Verification Report of Boomitra Grassland Restoration in Northern Mexico

Document Prepared by 4K Earth Science Private Limited

Report ID	25009-VCS-VER
Project title	Boomitra Grassland Restoration in Northern Mexico
Project ID	2887
Verification period	04/09/2018 to 03/09/2022
Original date of issue	23/05/2025
Most recent date of issue	16/02/2026
Version	7

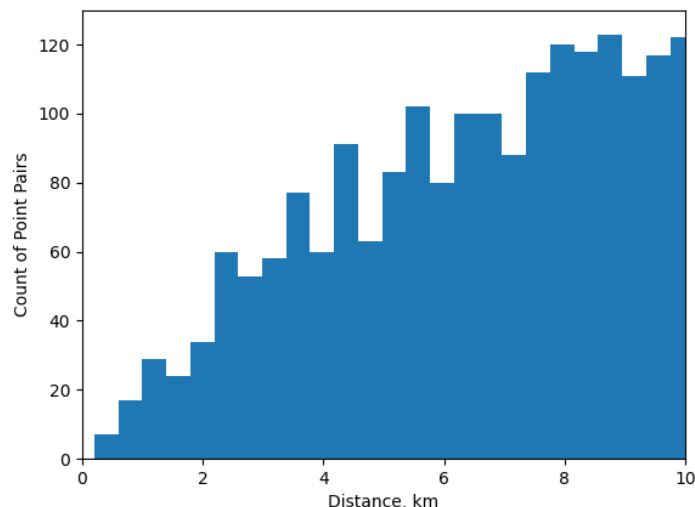
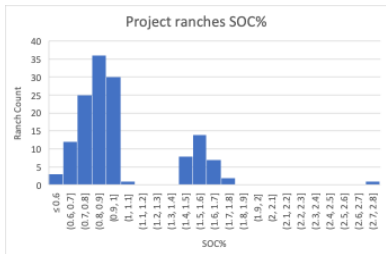
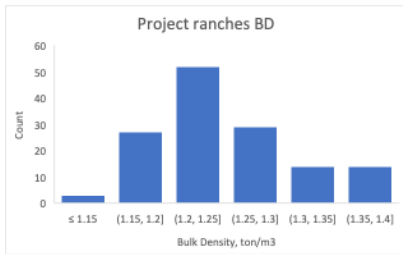
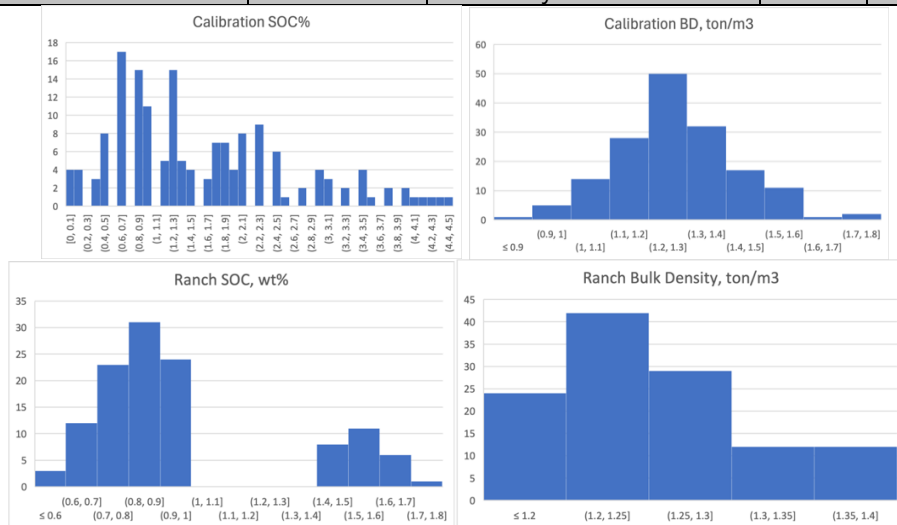
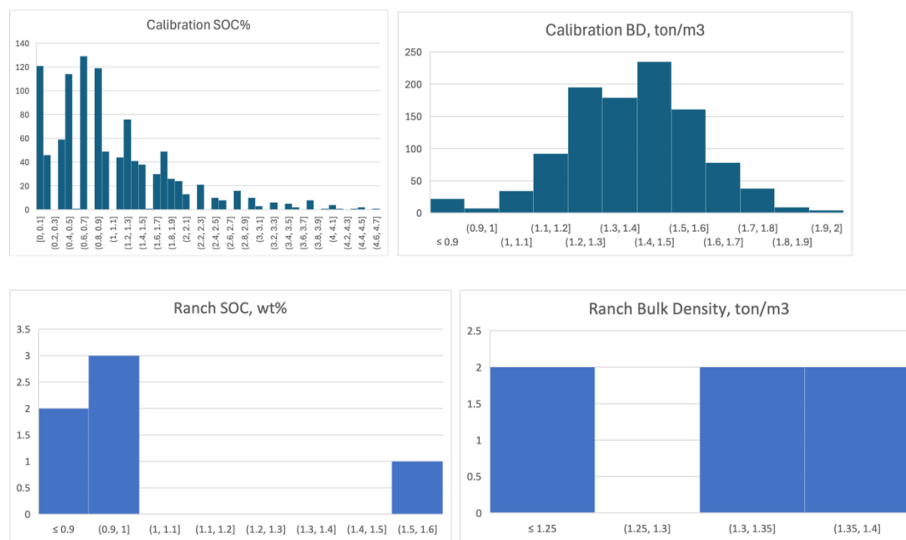
CAR ID	18	Section no.	Mexico SOC Remote Sensing Summary	Technical	Date:	02/05/2025
--------	----	-------------	-----------------------------------	-----------	-------	------------

other words, how can you demonstrate that your training dataset reliably represents the short range spatial variability within the ranch?

3. It is true that there are both short-range and long-range scales that are important for soil attributes. In particular, there may be heterogeneity at within-ranch scales that is only captured in a lesser manner than the overall long-range heterogeneity, which is well captured by the spatial spread of the training data. However, we can say that some short-range heterogeneity is indeed captured. This can be seen from a spatial correlation analysis:

Northern Mexico soil data spatial correlation plot of mean absolute difference between organic carbon soil samples as a function of separation distance. Observe that the Mean Absolute Difference is somewhat consistent across the distance ranges from 0 to 10km.

We find that there are indeed several point pairs at these distances, including some points that are less than 1km away from each other. Thus, at least some aspects of the short range variation are being covered.

Documentation provided by project participant						
Revised Mexico SOC Remote Sensing Technical Summary						
DOE assessment					Date :	12/05/2025
3. The response demonstrates that while long-range spatial heterogeneity is well captured by the training dataset, short-range variability is also represented through spatial correlation analysis and presence of closely located datapoints. The modelling framework incorporates averaging and semi variogram-based uncertainty analysis to account for residual short-range variability. The finding is closed.

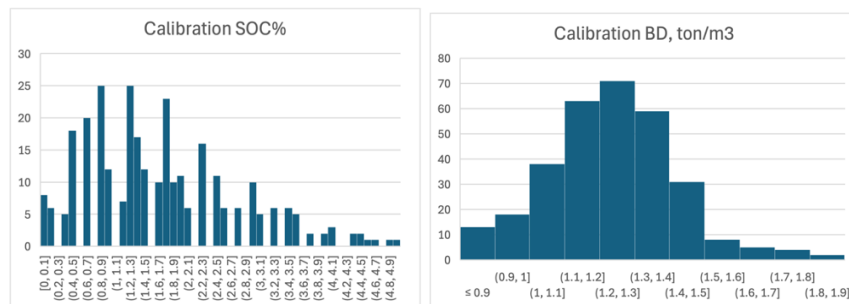
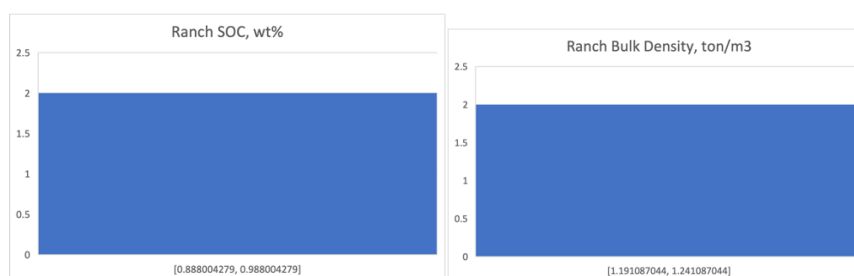
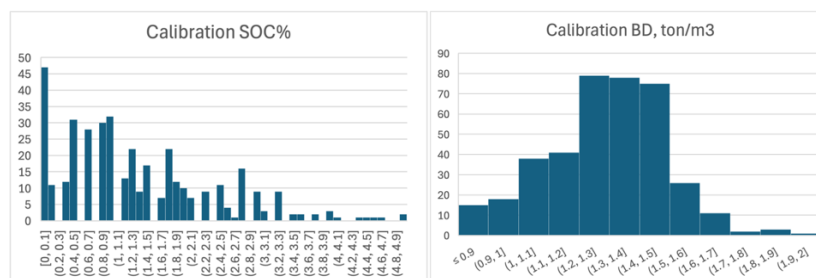
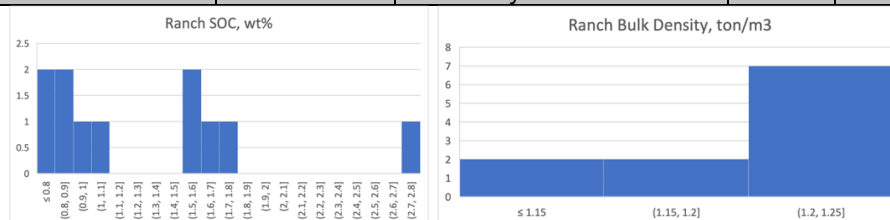
CAR ID	19	Section no.	Mexico SOC Remote Sensing Summary	Technical	Date:	02/05/2025
Description of CAR						
Please, provide clarification for this section in the document: Statistical distribution comparisons: Provide comparative distributions (e.g., histograms) of SOC, BD and soil texture from ranches versus: 1. The entire calibration dataset. 2. Data stratified by soil texture class.						
Project participant response					Date :	10/05/2025
Histogram of SOC% and BD in the ranches (produced directly from the emission removal excel spreadsheet):   Histogram of SOC% and BD in Calibration data are just Fig 7 in the document provided. Soil textures of ranches vs calibration dataset is directly present in the table before Figure 6. Stratified results by soil texture Sandy Clay Loam:

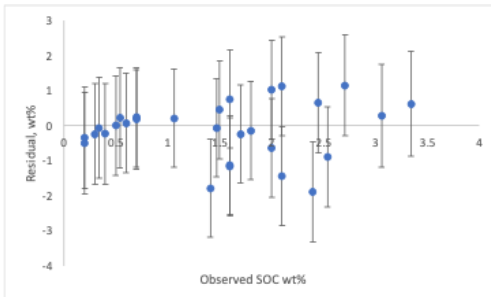
CAR ID	21	Section no.	Mexico SOC Remote Sensing Summary	Technical	Date:	02/05/2025
only during the driest months in the region (Eg. May). Temperatures are high and there is minimal rain, keeping the soil moisture levels very low. 5. Continuity is almost certain – the ALOS-4 satellite was successfully launched in 2024, which has the same SAR instrument as ALOS-2 and ALOS-1. The ALOS-2 has been operational since 2014. If we assume the same for ALOS-4, it should be operational until at least 2034. However, note that the project itself will undergo re-validation and baseline reassessment before that point, at which time the satellite model may be revised. Furthermore, these are not issues for the current verification of this project, which only spans 2018-2022. 6. The systems are built with a strong degree of redundancy. For example, later this year, the NASA/ISRO NISAR satellite will provide a similar dataset as that captured by the ALOS PALSAR. Likewise, the visible and infrared data from Landsat can be supplemented from Sentinel-2. In a case where a discontinuity happens, a spatiotemporal transfer function must be learned – which maps the pixel values of one satellite to those of another, for a collocated image in space and time. Discontinuity is not a current issue, however, as all the necessary satellites are still available. It is not an issue for the full period of the first verification, which is the time frame covered by this audit, from 2018-2022. 7. Within the context of this project's verification (2018-2022), we have not found persistent cloud/shadow to be an issue. Note that the project is located in a semi-arid region of Mexico where there are minimal rains and clouds for most of the year, except for the rainy season that is centered around July-September. Thus, it is possible to consistently get cloud-free images in the April-May timeframe when these analyses are done.

Documentation provided by project participant						
DOE assessment					Date :	12/05/2025
1. You have detailed the suitability of the radar imagery, ok. However, the evaluation of suitability for all other remote sensing datasets remains unresolved.						
Project participant response					Date :	10/05/2025
Beyond radar backscatter, our model incorporates a diverse set of satellite-derived covariates—including multispectral (Landsat), visible (Landsat), thermal (Landsat), and radiometer (SMAP/SMOS)—each selected based on documented relevance to soil and carbon dynamics. To evaluate their suitability: 1. Theoretical Justification: Each covariate was selected based on its capacity to reflect environmental drivers that influence SOC. For instance: ○ Vegetation bands reflect primary productivity and biomass, which are linked to organic matter inputs into the soil ○ Thermal bands help control for evapotranspiration and microclimate variation, which affect decomposition and carbon turnover. 2. Empirical Contribution to Model Performance We conducted feature importance analysis during model training, which demonstrated that these non-radar RS covariates have contributed significantly to predictive accuracy—especially in disambiguating the effects of vegetation cover and soil moisture on radar signals. Here are the feature importances of our gradient boosting model:

Revised Mexico SOC Remote Sensing Technical Summary					
DOE assessment				Date :	12/05/2025
PP has provided a detailed and well-substantiated explanation for the use of satellite-derived covariates beyond radar backscatter in the SOC modeling approach. The response outlines a clear theoretical basis for selecting multispectral (Landsat), visible, thermal (Landsat), and radiometer (SMAP/SMOS) data, citing their relevance to key environmental drivers of SOC such as primary productivity, evapotranspiration, and microclimate variation. PP also presented empirical evidence through feature importance analysis in a gradient boosting model, demonstrating that these covariates significantly enhance model performance by helping differentiate vegetation and soil moisture effects on radar signals. Additionally, the use of multimodal inputs is shown to improve robustness by reducing noise from transient landscape conditions. The justification provided is adequate and addresses all concerns regarding the inclusion and role of non-radar remote sensing data in the model. All findings are hereby closed.

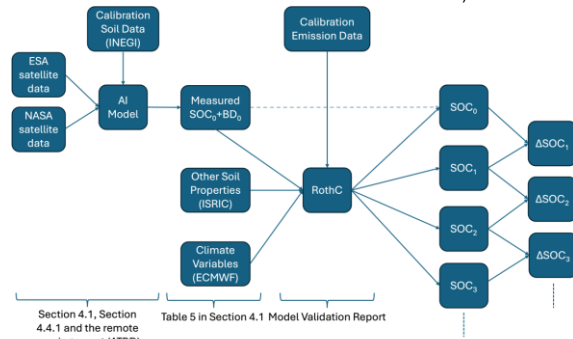
CAR ID	22	Section no.	Mexico SOC Remote Sensing Technical Summary	Date:	02/05/2025
Description of CAR					
Theoretical basis: Assumption 1: - How do the vegetation cover percentage and the incidence angle affect the linear relationship between SOC and the backscatter (Figure 8)? Are these variations accounted for? - Why set of covariates used for soil predictions are different from set used for matching ranches to control plots? - The paragraph before Figure 9 is unclear. Clarify how Sentinel-1 was used, for what purpose, and why it was chosen? How does it contribute to the overall methodology, and how does it compare to ALOS in terms of its role in the analysis?

CAR ID	22	Section no.	Mexico SOC Remote Sensing Summary	Technical	Date:	02/05/2025
4. What does "net change in backscatter" refer to in this context? Does it represent an absolute difference, a relative change, or a normalized variation in backscatter values over time or across different conditions? How is it calculated, and what is its significance in the analysis?						
Project participant response					Date :	10/05/2025

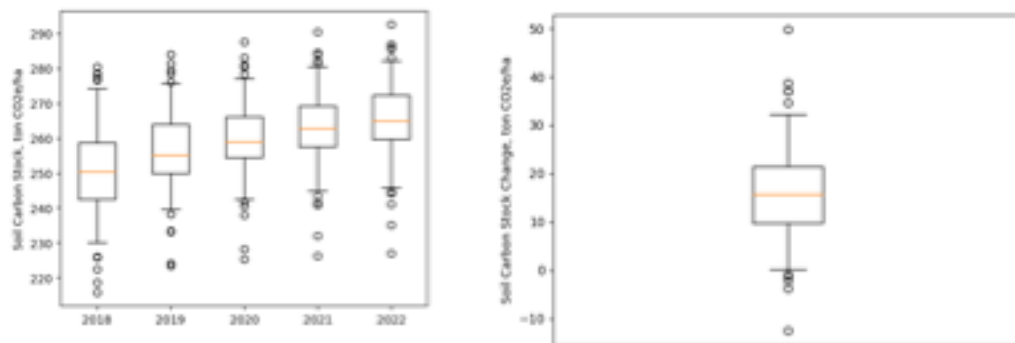
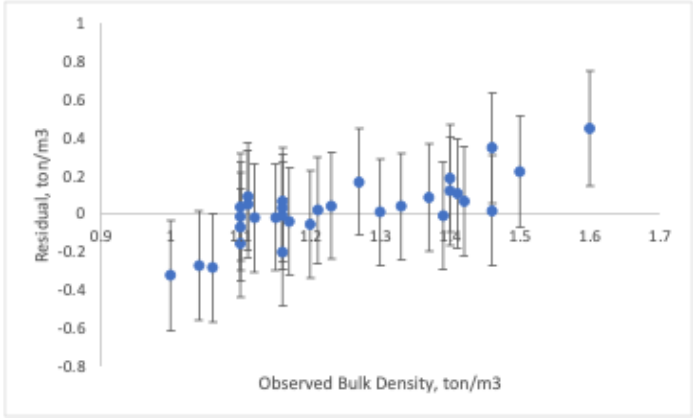
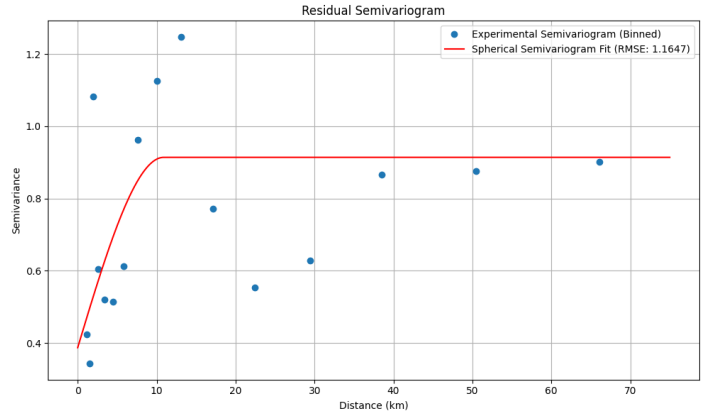
CAR ID	23	Section no.	Mexico SOC Remote Sensing Summary	Technical	Date:	02/05/2025												
Description of CAR																		
SOC model training:																		
1. Please, provide additional global performance metrics (e.g. MAPE, CCC, RPIQ), and stratified by textural class if possible. 2. Indicate whether strata were used as a covariate and how they were incorporated into the analysis or models. 3. The model appears to overestimate SOC for values above 2% in figure 11. Please, provide external validation with independent data (different from the train and test sets) and display the SOC distributions for both datasets. 4. Please, report the percentage of predictions (coverage) within the prediction interval (count number of points inside/outside of predicted interval), and provide a residual prediction plot sorted by prediction interval.																		
Project participant response					Date :	10/05/2025												
1. Note that it is common for models to have better performance on training data than test data – this is the purpose of having a test dataset: Accuracy Epoch Training Set Accuracy Test Set Accuracy Overfitting Early Stopping Epoch We have carried out an extensive model selection process to minimize mean squared error on the test data. We have tried techniques including – random forest, support vector machines, kernel ridge regression, neural networks and more. After experimentation, it was found that gradient boosting with the given hyperparameters achieved the best results on the test dataset, and as a result, it was used in this work. On the additional metrics requested, we have added them here:

2. The response is satisfactory but could you please provide more details on how you validated the Δ SOC (the SOC change) between time points (e.g., by comparing Δ SOC _{observed} vs. predicted Δ SOC)? Additionally, how can you be confident that the systematic errors present in the absolute SOC predictions at each time point are effectively canceled out when the values are subtracted? Is this an assumption, or did you actually quantify and verify the error cancellation?					
Project participant response				Date :	10/05/2025

1. Given that the train and test sets are randomly partitioned from the same calibration dataset (INEGI dataset), the observed degradation in performance is not due to distributional shift, representativeness, or sampling campaign differences. Instead, the reduction in performance from train to test is expected and attributable to the following: 1. Noise in Soil Data: Soil data inherently includes high natural variability and measurement error, even within small spatial areas. Since both train and test sets contain noisy measurements, the model may inadvertently learn spurious correlations in the training set that do not generalize well to the test set. 2. Model Generalization vs. Memorization: The performance difference reflects the model's generalization capability. On the training set, the model captures idiosyncrasies specific to the training data. The test set, being unseen, provides a more honest assessment of how well the model captures underlying patterns rather than specific instances. 3. Heteroscedasticity and Non-linear Interactions: The prediction task involves complex, non-linear interactions between features (e.g., infrared vegetation measurements, radar backscatter), and potentially heteroscedastic errors—where prediction uncertainty increases at higher SOC levels. These characteristics limit model performance even when training and test data are drawn from the same population. 4. High Dimensional Covariate Space: The remote sensing input space is high-dimensional, and although the training and test sets are from the same distribution, the model's performance can vary due to local sparsity in covariate space. In some areas of the feature space, the density of training samples may be lower than in other parts of the feature space, resulting in differing test accuracy in these areas of the feature space. For example, this is a known issue for higher ranges of soil organic carbon (most of which may also be above the relevant range for predictions in this project's ranches). Soil organic carbon data is known to be skewed, particularly in arid regions and degraded regions – there are much larger numbers of soil samples at low soil carbon levels than

We then empirically see the significant drop in standard error after subtraction of the PPDs across time. You can see this in the example provided in the main document where the uncertainty drops with subtraction:

The half-width of the boxplot (90% confidence interval) has gone from +/- 20 tonCO2e/ha in the SOC stock to +/- 15 tonCO2e/ha in the SOC change. If the variances were independent and did not have this systematic error contribution then we would have $\text{SQRT}(20^2 + 20^2) = 28$ ton CO2e/ha as the error in the difference, but the actual error is nearly half of this. This is due to the systematic upward or downward deviations of individual MC simulations, which, when subtracted, drop out, as described in an earlier response. These systematic deviation include in them the effect of the static variable exclusion. This does not guarantee, however, that ALL the effects of the static variable exclusion are cancelled out. If there is any uncanceled residual error remaining arising from the static variable exclusion, it ultimately remains in the final uncertainty calculation. Thus, it makes its way to the project-level uncertainty deduction and final carbon credit quantification, and the integrity of the project is maintained.

DOE assessment	Date :	12/05/2025
1. The model selection process involved multiple techniques, with Gradient Boosting achieving the best performance on the test data. Additional metrics show acceptable performance, with MAPE at 52%, CCC at 0.693 (moderate/good), and RPIQ at 1.86. The drop in performance from train to test is expected due to inherent soil data noise and complex feature interactions. This finding is closed. 2. Strata were excluded as covariates to prevent overfitting to spatial patterns and to focus on temporal changes in SOC. The PP used strata for dataset representativeness but ensured model performance was not hindered by static variables. The exclusion of strata is justified,

CAR ID	23	Section no.	Mexico SOC Remote Sensing Technical Summary	Date:	02/05/2025
as systematic errors from this exclusion are mitigated when calculating SOC change. This finding is closed. 3. The observed overestimation for SOC >2% is due to increased noise, not bias. Validation using independent datasets confirmed that the model meets Verra's criteria (90% prediction interval coverage, $R^2 > 0$, and low bias). The model's predictions align closely with the independent RothC model (6.9% difference), validating SOC change estimates. This finding is closed. 4. The model's 90% prediction interval coverage is 89.7% for the test data, meeting Verra's threshold. Residual analysis shows that systematic errors cancel out in SOC change calculations, reducing uncertainty. This finding is closed.

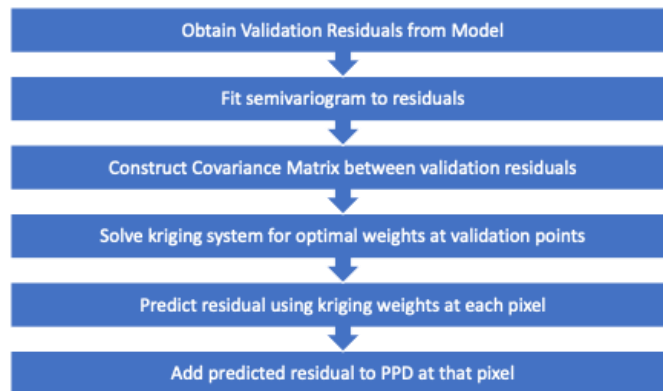
CAR ID	24	Section no.	Mexico SOC Remote Sensing Technical Summary	Date:	02/05/2025												
Description of CAR																	
Pedotransfer function (PTF): 1. Please, provide additional global performance metrics (e.g. MAPE, CCC, RPIQ), and stratified by textural class if possible. 2. Figure 12 indicates bias in BD predictions (overestimation at low BD, underestimation at high BD. Please, provide external validation with independent data (different from the train and test sets) and distribution for both datasets. 3. Please, report the percentage of predictions (coverage) within the prediction interval (count number of points inside/outside of predicted interval), and provide a residual plot sorted by prediction interval.																	
Project participant response				Date :	10/05/2025												
1. See the similar response in the section above. In the case of the PTF, we also tried many model architectures including random forests, support vector machines and ridge regression, before settling on gradient boosting with 30 estimators, which minimized error on the test dataset. We can also provide the additional performance metrics below, but note that Verra has narrowed down on 3 specific validation metrics (stated in FAR05 in validation report, R2, PICP and bias). Additional Metrics:

1. Yes, the anthropogenic factor is the land management history. The bulk density at a certain point in time is a function of the sand, silt, clay, soil organic matter, and the land management history, as detailed in the theoretical section of the main document. In particular, the land management history that is of importance is any activity that leads to compaction. A common example of such an activity in agriculture is the transition from tillage to no-till, which leads to soil compaction in the short term. However, in this native grassland project, there is no tillage in both baseline and project scenarios, so this is not an important effect. The more likely anthropogenic effect underpinning the bulk density in this work is simply the level of grazing stress experienced by the land over the course of decades. For example, land that has been severely overgrazed compared to the average situation in the region is more likely to have exposed soil that is then eroded and ends up exposing deeper more-compacted soil layers, artificially causing the top 30cm to become "more compact" because the less compact layers have eroded. In this situation, we would technically also see a lower soil organic carbon level (as SOC typically decreases with depth), so the effect is partially captured by the incorporation of soil organic carbon as a PTF input. However, there may be a component that is not fully captured by soil organic carbon (for example, imagine an extreme case where the soil organic carbon profile with depth in the original soil before degradation was relatively constant, so the PTF is unable to calculate a higher bulk density). Note that this source of error would only occur when the degree of anthropogenic land degradation is different from the average scenario in the region that is already represented in the calibration data. This remaining anthropogenic degradation variable is unaccounted for in the PTF, because it is hard to precisely quantify, particularly for the INEGI samples collected in the past, so it may explain some part of the performance metric reduction from train to test set. Given the difficulty in gathering this information for each INEGI soil samples taken from 2005 to 2012, or finding an alternative bulk density dataset with sufficient data points that also has this information, we are unable to add this as a parameter into our model, and have to settle for what the current covariates are able to provide.

Documentation provided by project participant					
DOE assessment				Date :	12/05/2025
The anthropogenic factor affecting bulk density is primarily land management history, particularly grazing stress. While soil compaction from tillage is not relevant here due to no-till practices, overgrazing can cause erosion, exposing deeper compacted soil layers. This effect is partially captured by soil organic carbon in the PTF, but there may be unaccounted degradation, particularly if original SOC profiles were uniform. The lack of detailed historical data for INEGI samples limits the ability to incorporate this variable, which could explain the performance metric reduction from training to test sets. This finding is now closed.
